Building grant. Recording with refce to
G.O. No. 165 Edl of 15.2.15 letters from the
D.P.I. recommending — for the Hindu
Theological High School, Madras.

Recommending a half grant for making certain additions and improvements to the accommodation of the Hindu Theological High School, Madras.

Submitting revised plans and estimates relating to the Hindu Theological High School, Madras and recommending that a half grant of Rs. 9,300 may be sanctioned on the total cost of the revised estimate.

Report to accompany the revised plans and estimates for the
Proposed additions and Improvements to the Hindu Theological
School, Madras.

SITE PLAN
K.F.D. No. 21

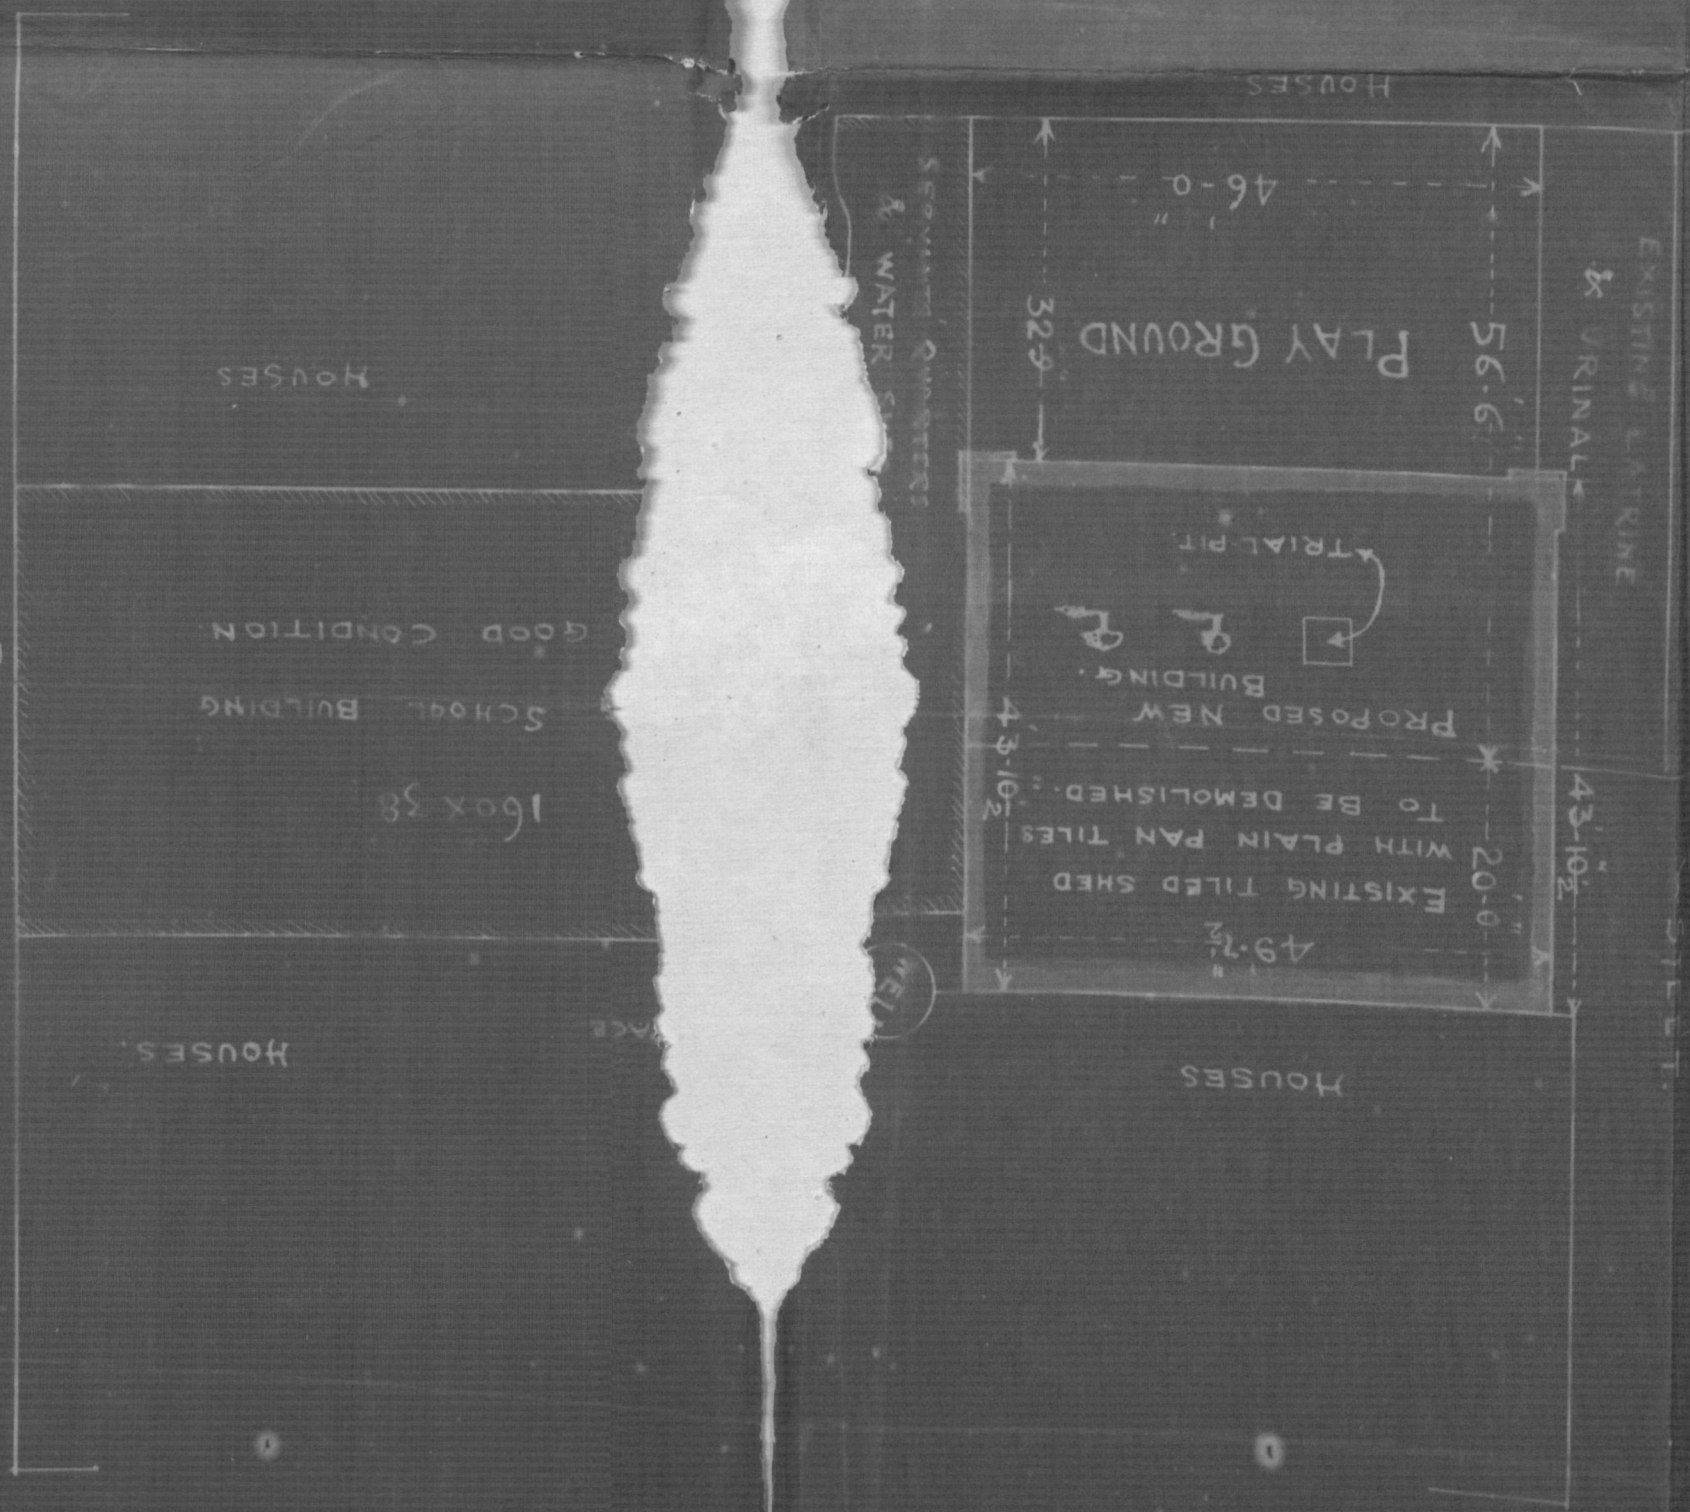
VI The Superintending Engineer should satisfy himself that the foundations provided are suitable and that the existence of the well in rear shown on site

plan D.P.I.No.41 does not affect the foundations and walls of the proposed building.

B.P.D. No. 42B

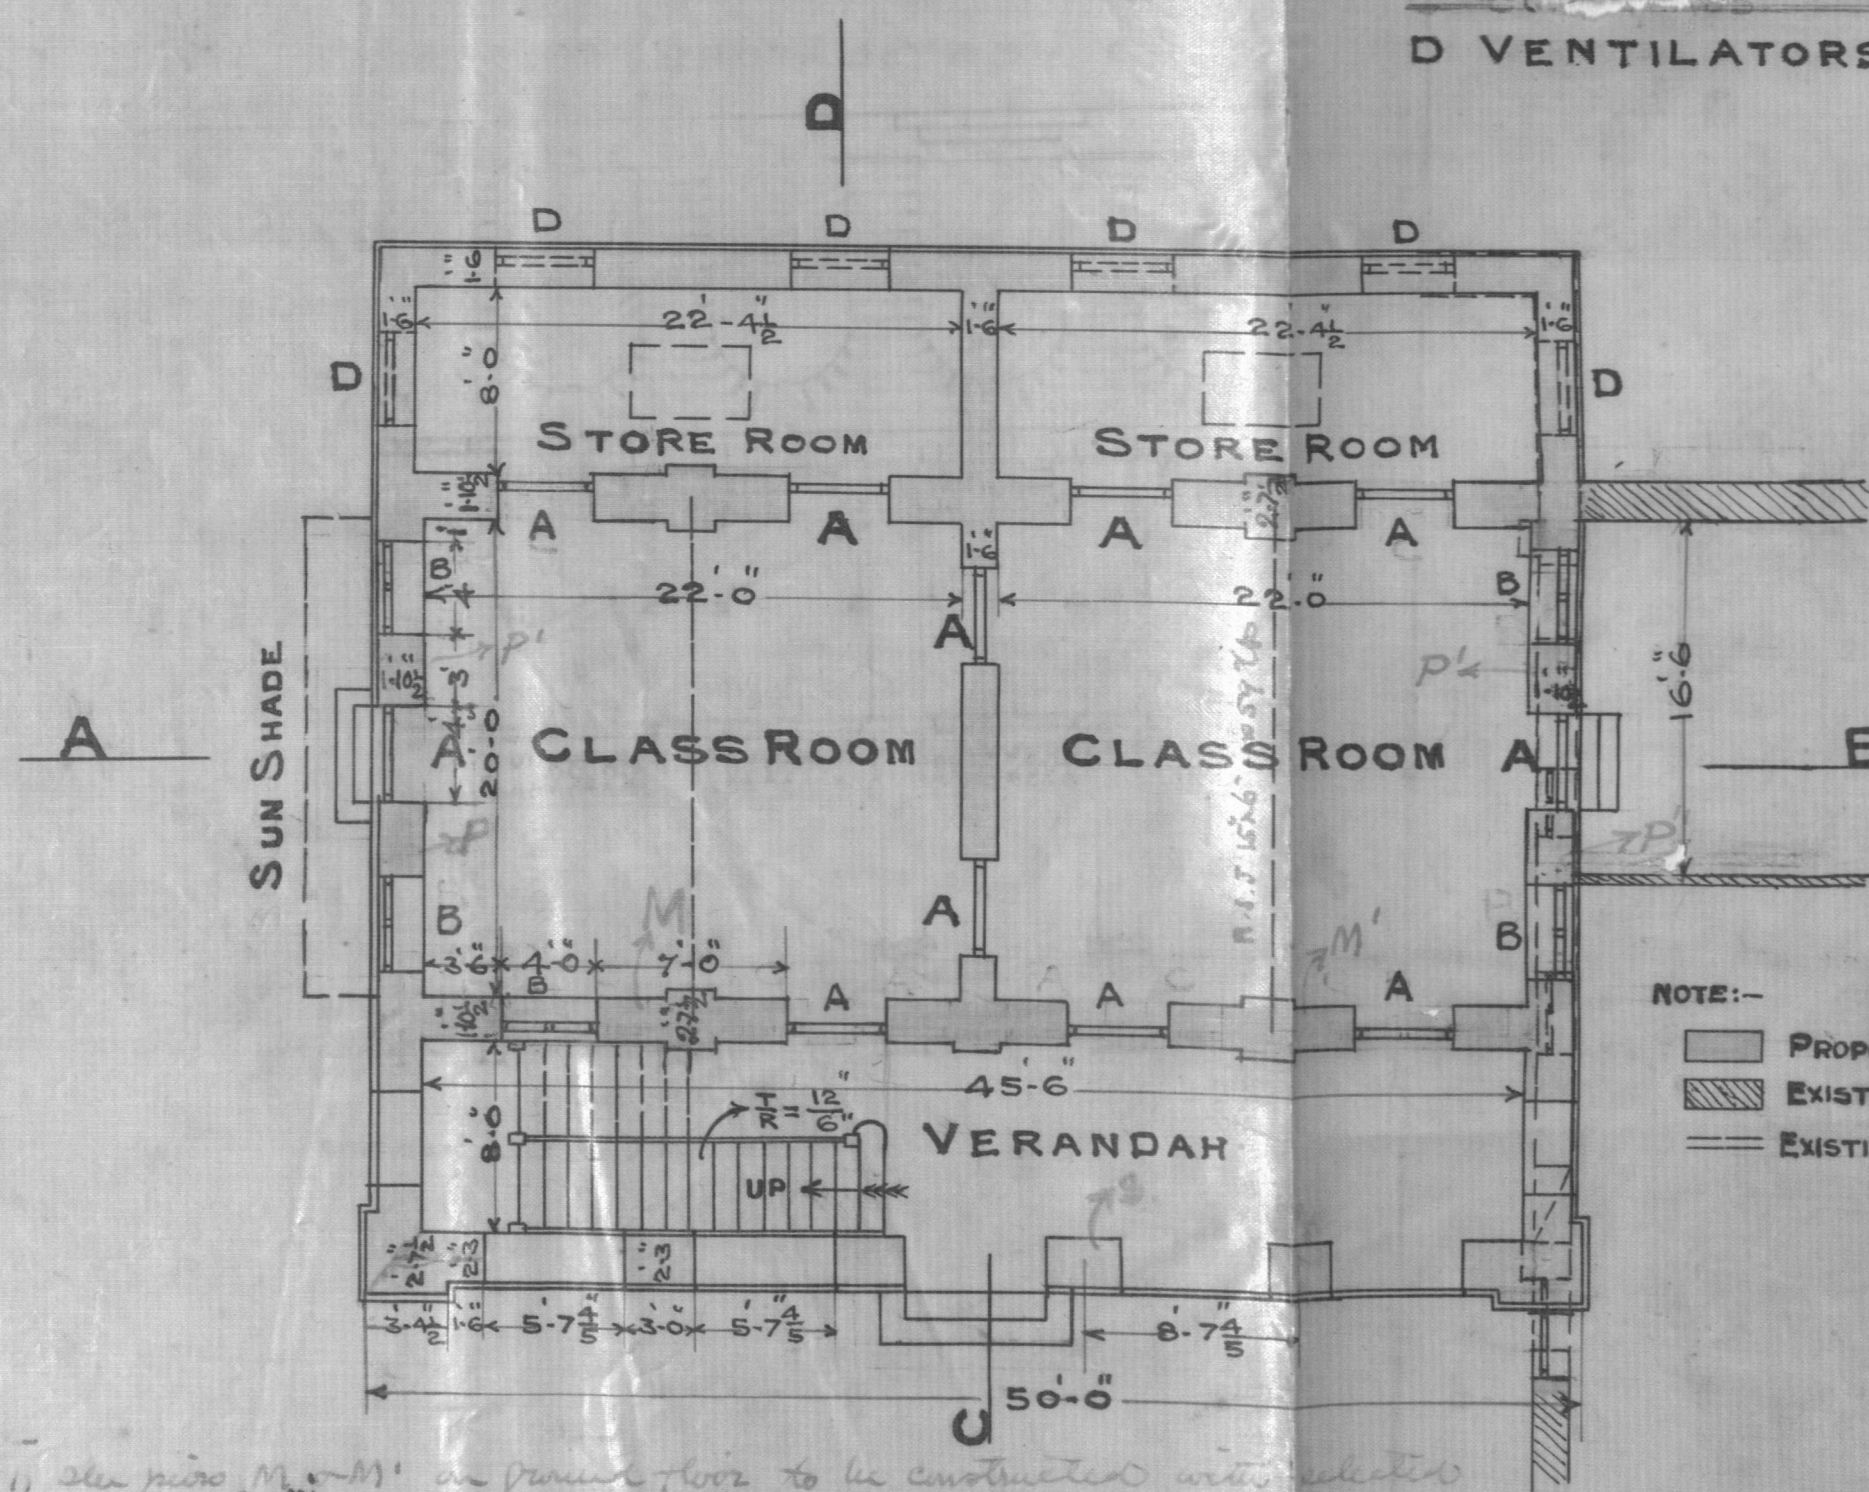
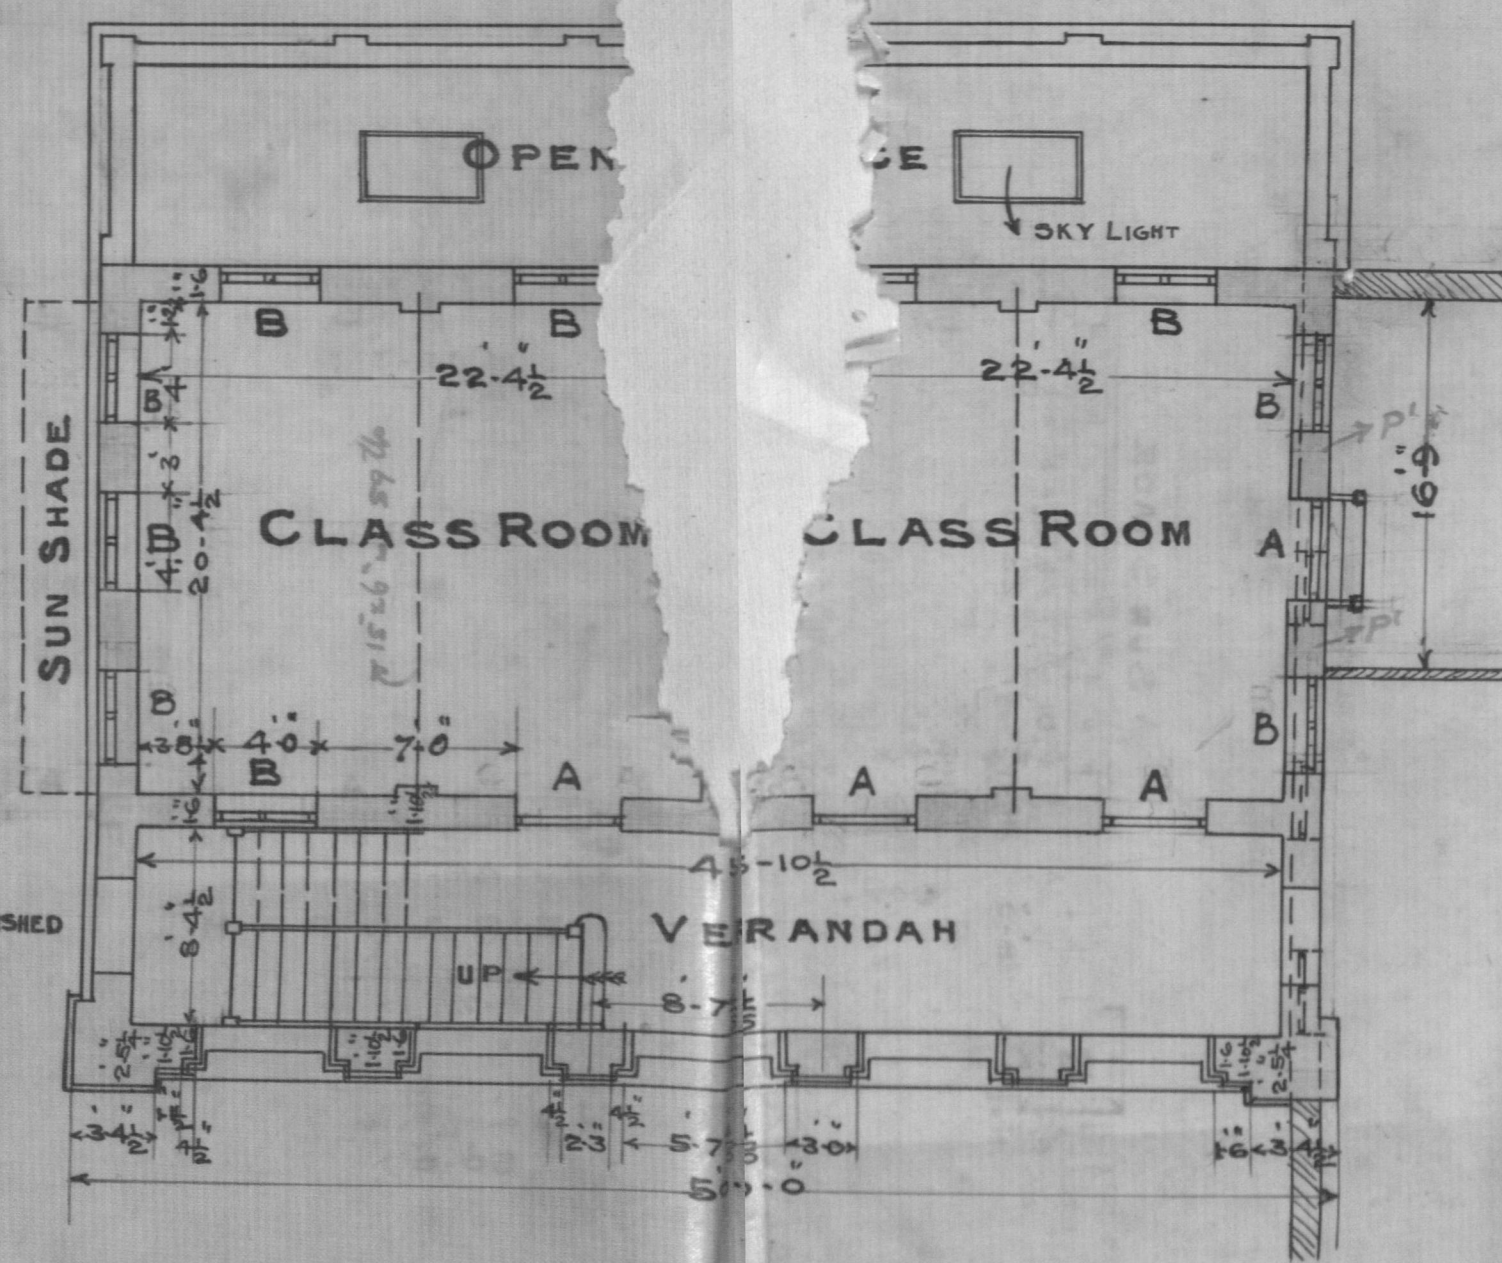
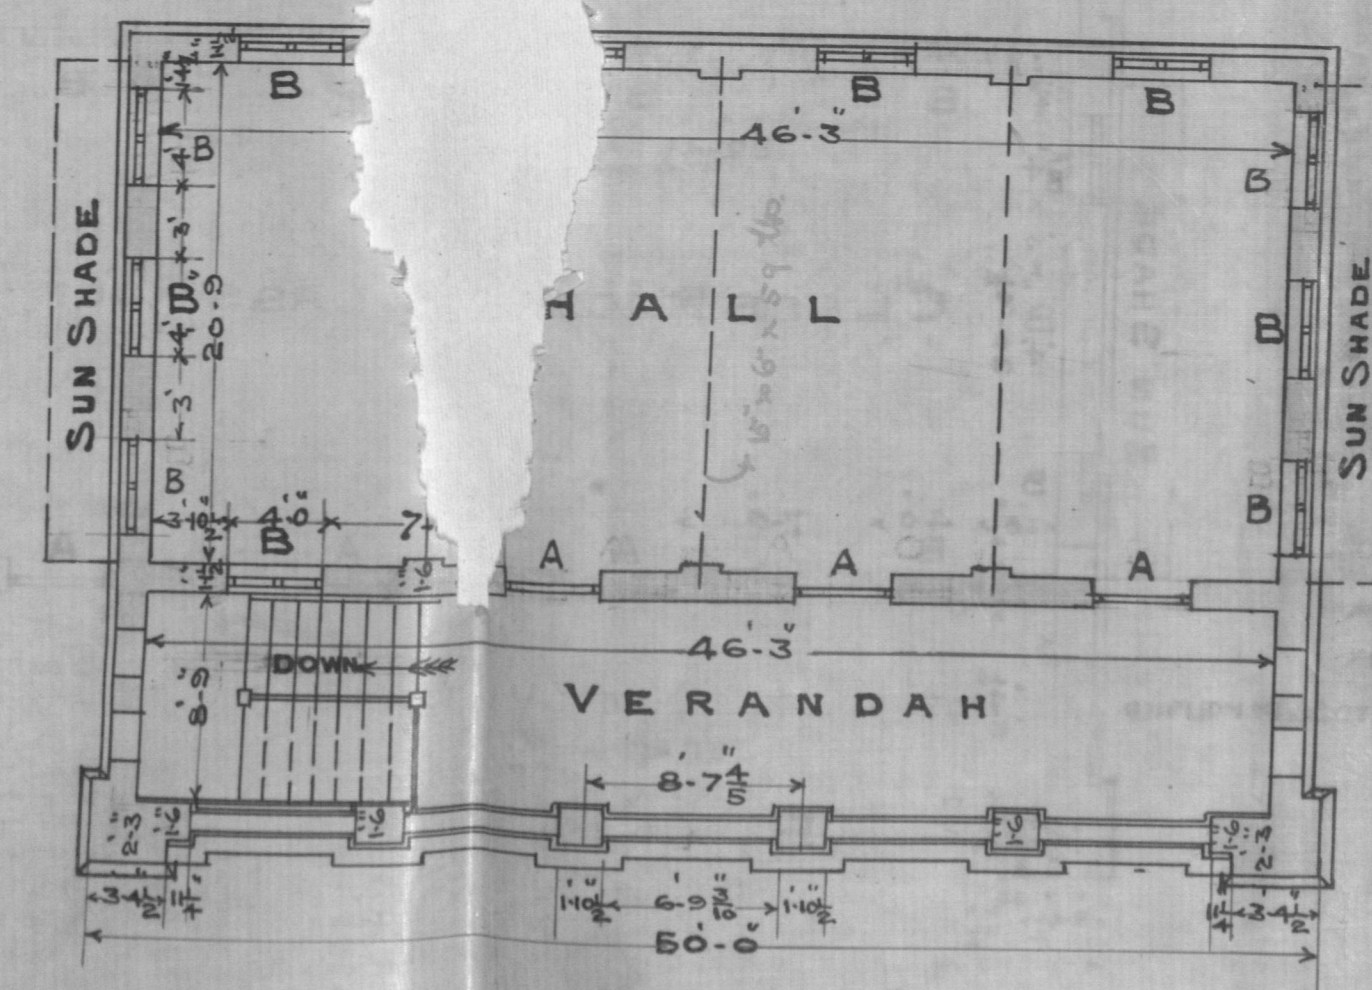
(a) The pressure on the piers marked A at basement level is 8.18 tons per square foot and they should be redesigned so as to reduce it to 4 tons per square foot.

(b) The pressure on the piers marked B at basement level is 5.46 tons per square foot and they should be redesigned to reduce it to 4 tons per square foot.

(d) The large arches on the ground floor are not safe. The pressure at the springing of the arch is 15.62 tons per st. ft which is much above the safe limit and the resultant of the thrust of the arches is found to fall outside the base of the abutment.

(1) Constructing piers marked P and P' on plan D.P.I.No.42-B with cement instead of lime mortar, the additional cost involved to be met from the amount provided for "unforeseen works."

III. The piers marked M & M' should be constructed with bricks carefully selected

NOTE:-
(1) See plan No. 42B on ground floor to be constructed with concrete.
(2) See plan No. 42B on ground floor to be constructed with brick in cement.
